INSTRUCTION TO SERVICE

ITS: 5659

SECTION:	241 Fuel System
WRITTEN BY:	Mike Pearson
SUBJECT:	Replace Existing CNG Fill Box Expiry Date Decal

Figure 1: CNG Tank Decal Expiration Date Location

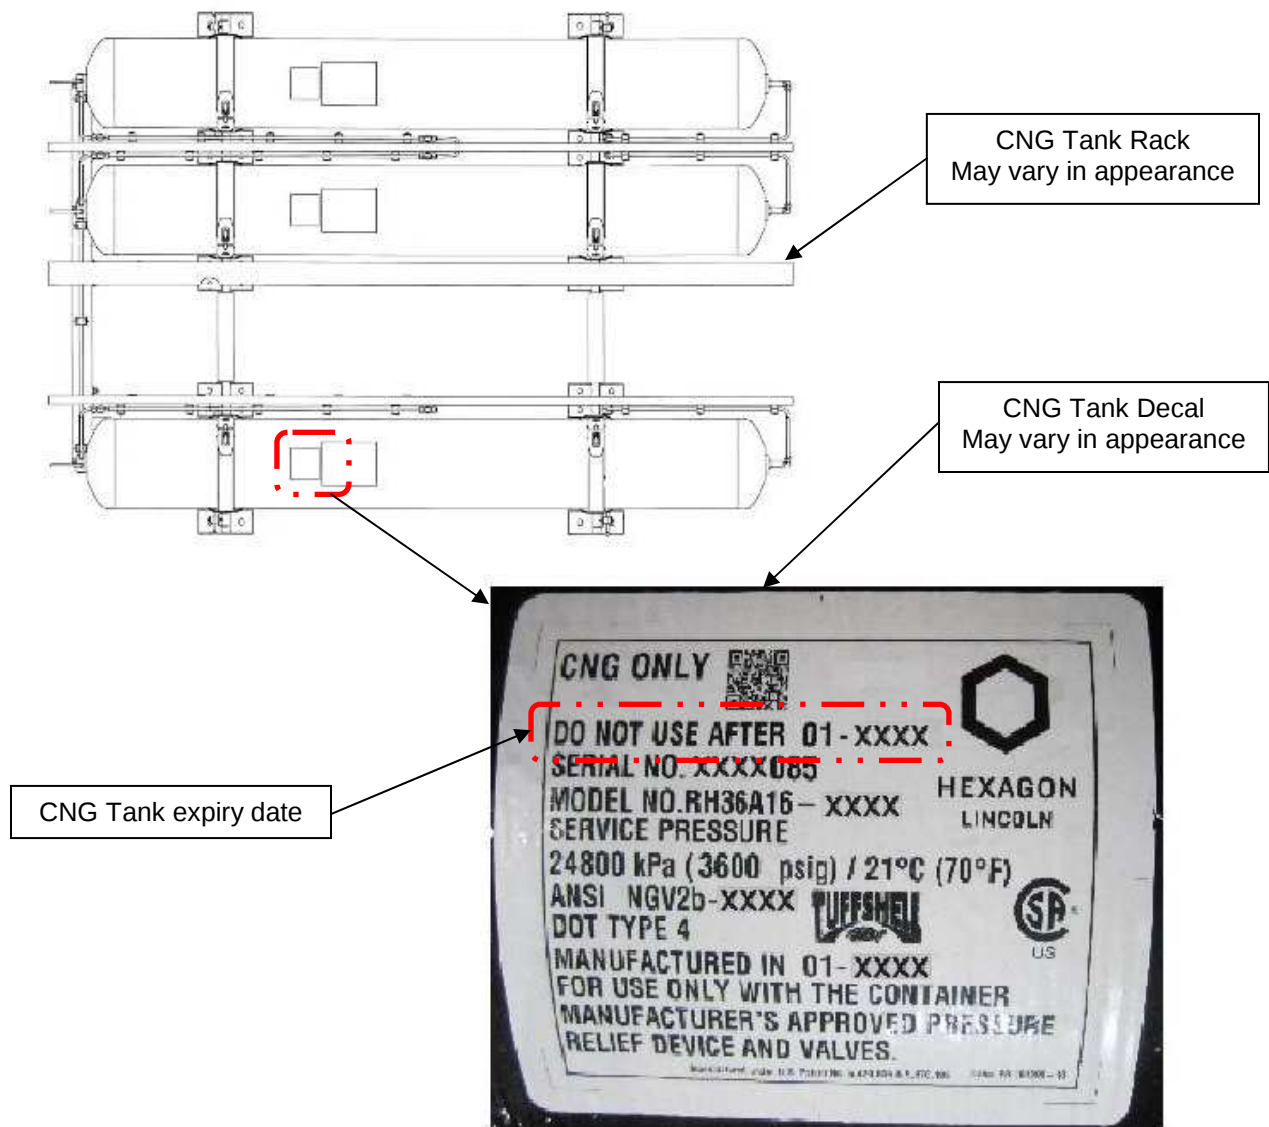
1. Turn the main battery disconnect switch to the "OFF" position.
2. Using approved fall safety protection equipment, locate and examine the CNG tank decals on the roof. Located as shown in Figure 1.
3. The CNG tank decals should all have the same "**DO NOT USE AFTER**" date on them. The decals may vary in appearance but will always have a "**DO NOT USE AFTER**" date on them.
4. Record and compare the expiry date from the tank decal to the existing fill box decal, shown in Figure 2.

6. The “**DO NOT USE AFTER**” date on the CNG cylinder decal (See Figure 1) should be the same year as the “**CYLINDER EXPIRATION**” date on the Fill box decal (See Figure 2).
7. If the decals expiration/do not use after dates do not match then the fill box decal will need to be changed.
8. Peel off existing fill box decal, clean area and apply new decal p/n 543662.

Figure 2: CNG Fill Box Decal Expiration Date Location

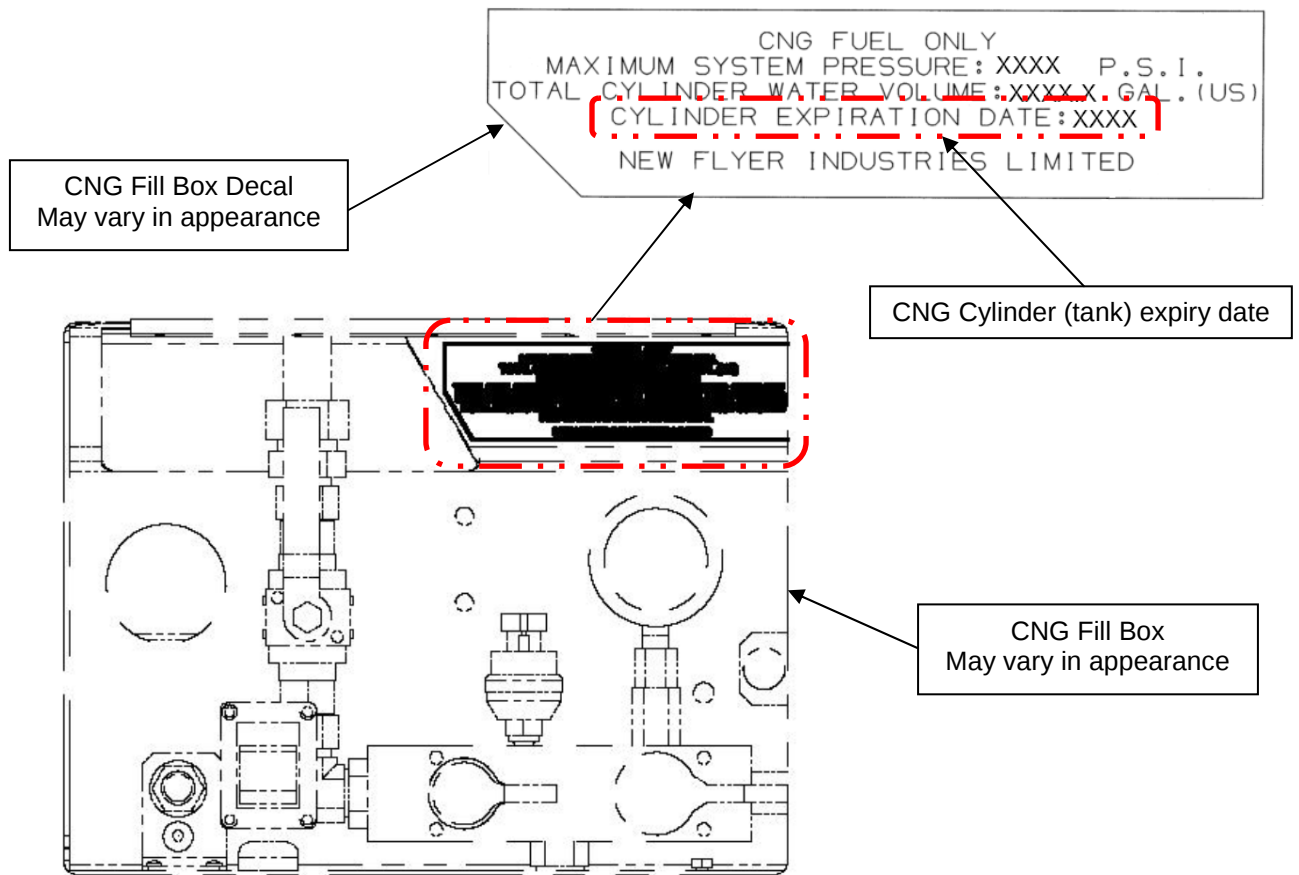
5. Open the CNG fill door at the curbside rear of the coach and locate the existing CNG Fuel Decal on the upper right face of the fill box as shown in Figure 2.
